Martin Slough Multimodal Trail
PWP # DO-2022-043
Federal Project Number TAP-0005(002)

Addendum #01

Wednesday, November 10, 2021

Carsonite LineMarker™

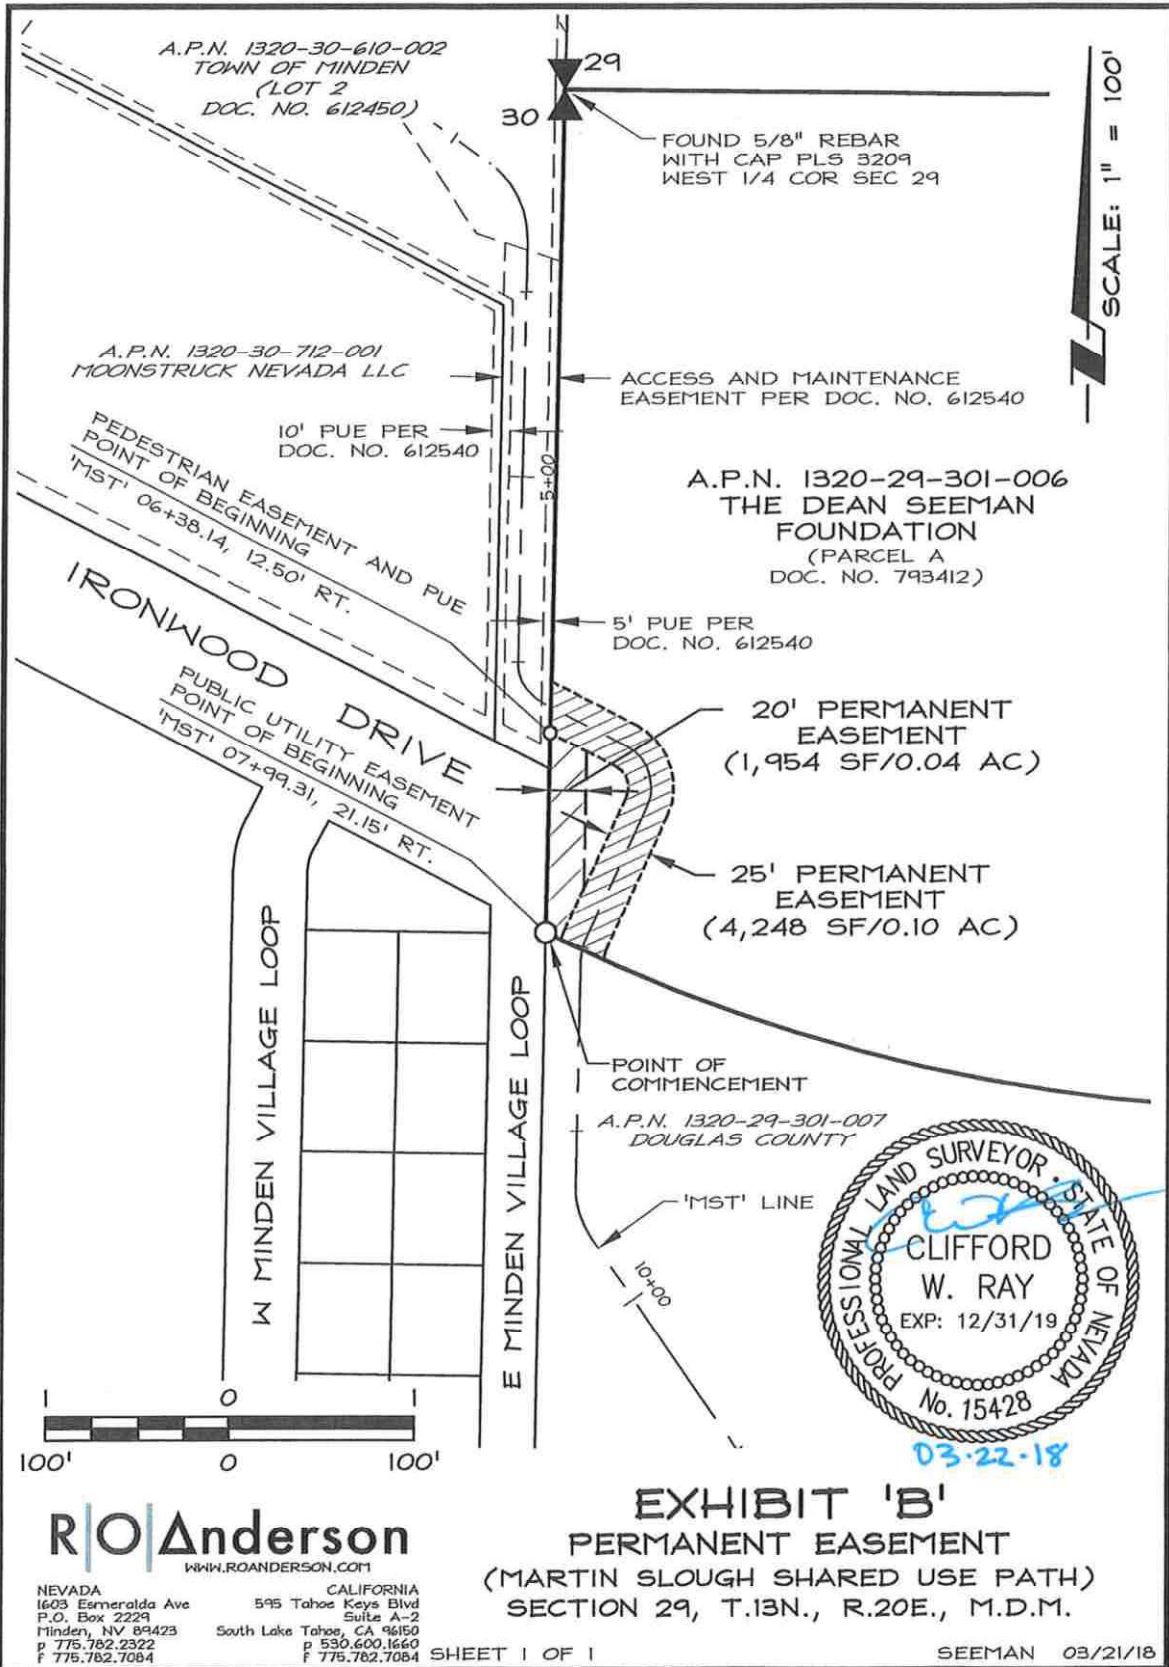
7. Sheet C19. We show two Fiber Markers per box; can we reduce this to one Fiber Marker per box?
Yes.
 8. Can we get a specification or cut sheet on the Fiber Marker?
A specification for the fiber marker is included with this addendum as Exhibit 3.

HANDHOLE DETAIL

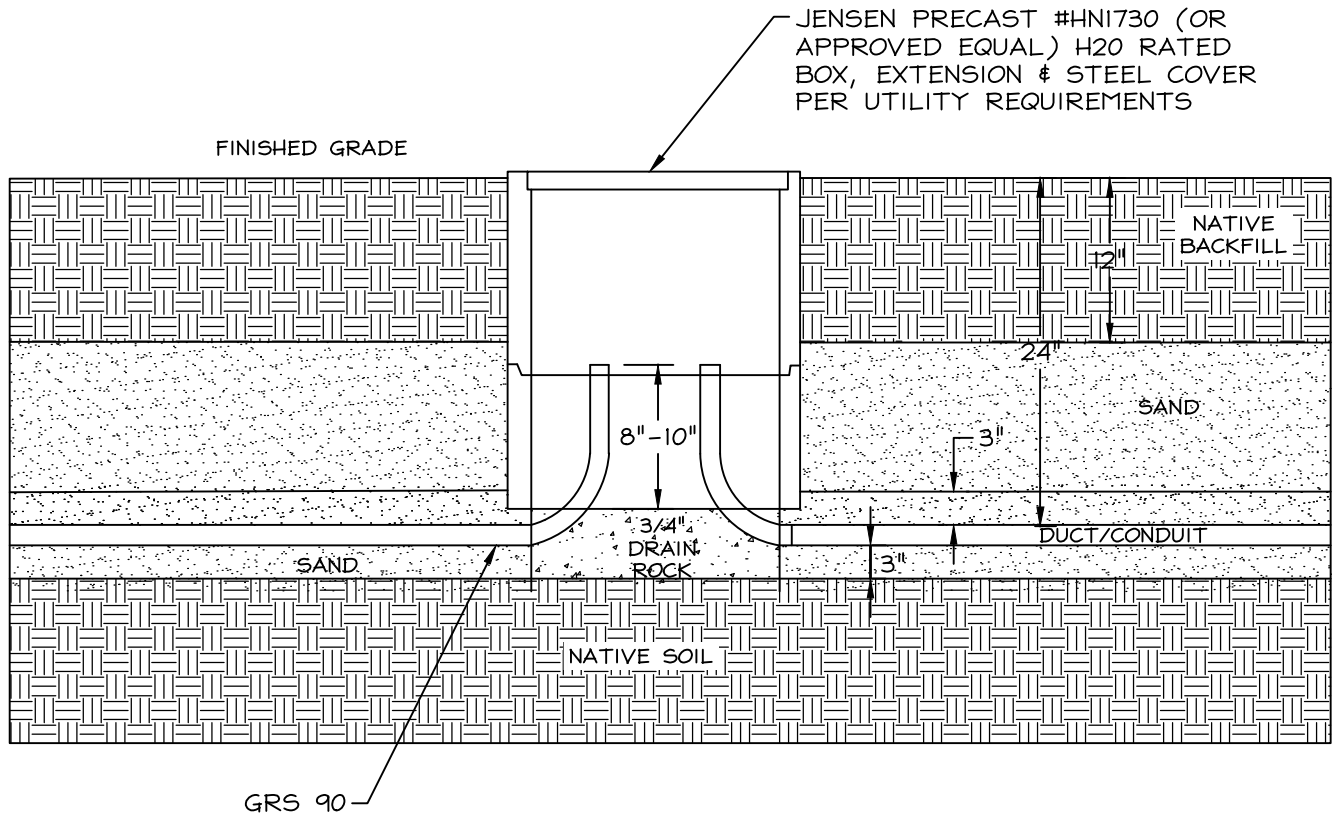
6. Sheet C19
 - a. Replace the "Typical Fiber Pull Box" detail on this sheet with the detail provided as Exhibit 5 included with this addendum.

e. Can you clarify how the utility bundle is supposed to be left at the pull boxes?

See updated pull box detail attached as Exhibit 5.

Confirmed. The pull boxes (in some cases referred to as hand hole boxes) for the fiber utility will be provided by the owner and installed per the updated detail by the contractor.
